## Rapport de controle

| XXX COTE MAJEURE A CONTROLER A LA RECEPTION | désignation BASE Z AXIS | numero/number: 55562 | Indice plan 01 | |

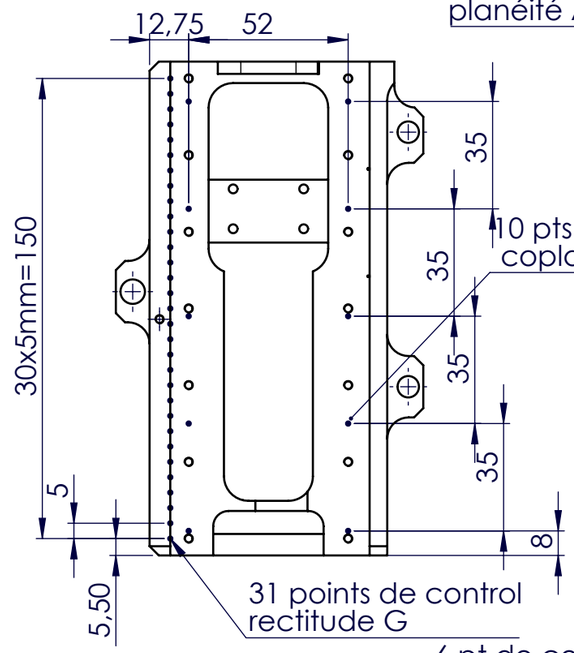
Faire un rapport de controle
de la surface G
1 point tout le 5mm.

8 points de mesures
planéité A

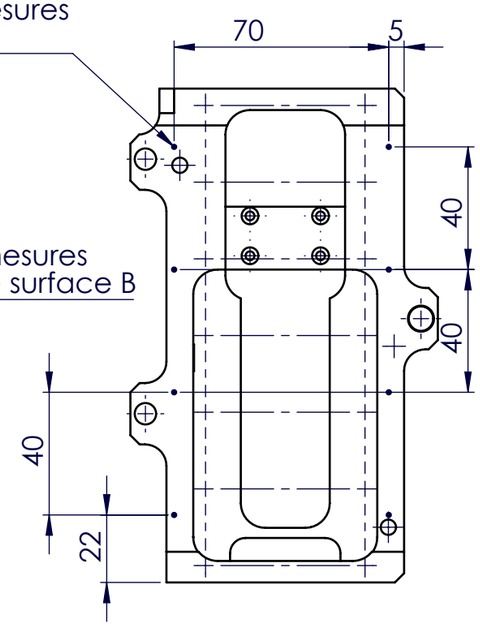
6 pt de controles
planéité I

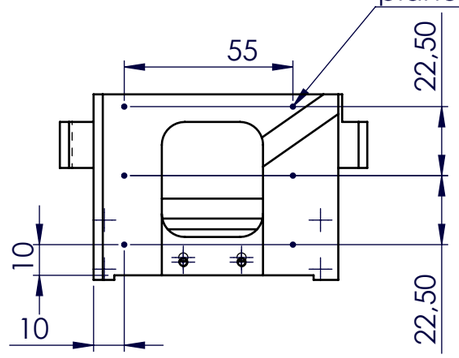
Mesurer le défaut de perpendicularité
entre G et I
